AMENDMENTS TO THE DRAWINGS:

In the Office Action at item 2, the Examiner objected to the drawings. In order to overcome these objections, replacement figures are submitted herewith. In FIGS. 6, 16, 17A-17D, and 18, each figure has been labeled as "PRIOR ART." Approval of these changes to the Drawings is respectfully requested.

FIG. 6

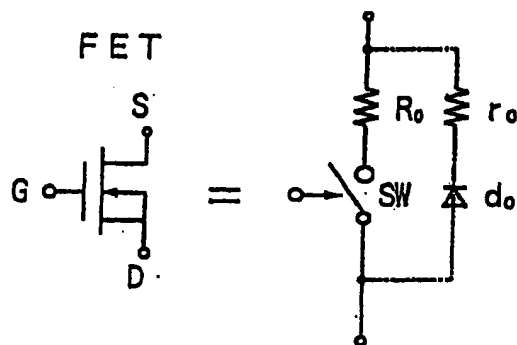
PRIOR ART

The Drawings has been approved by Examiner

FIG. 16

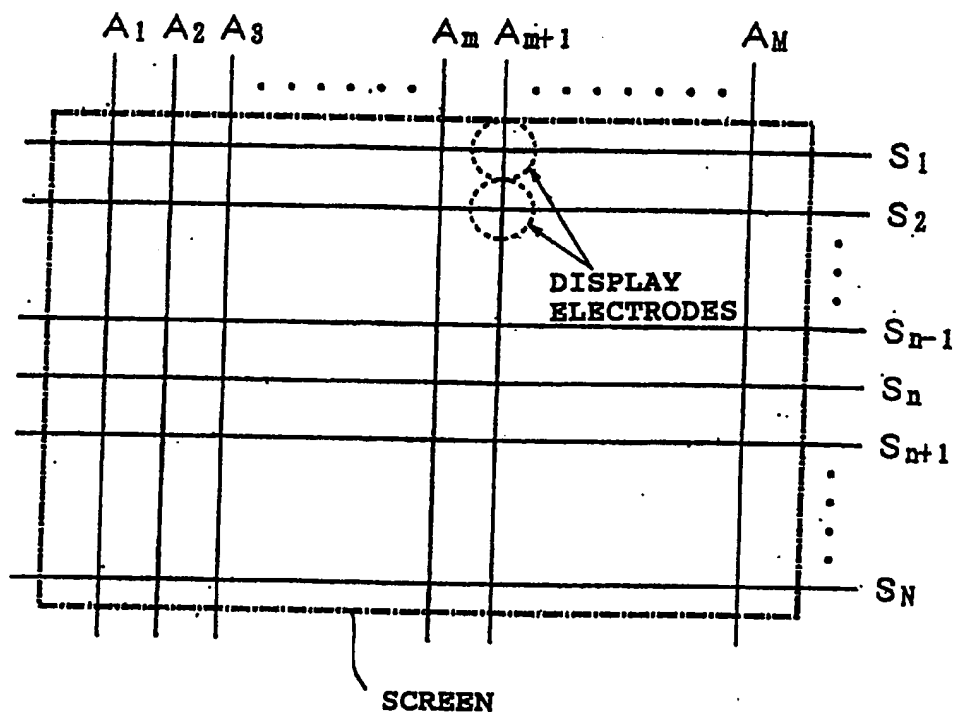
PRIOR ART

FIG. 17A

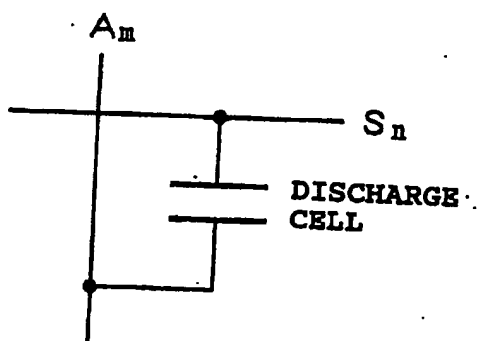
PRIOR ART
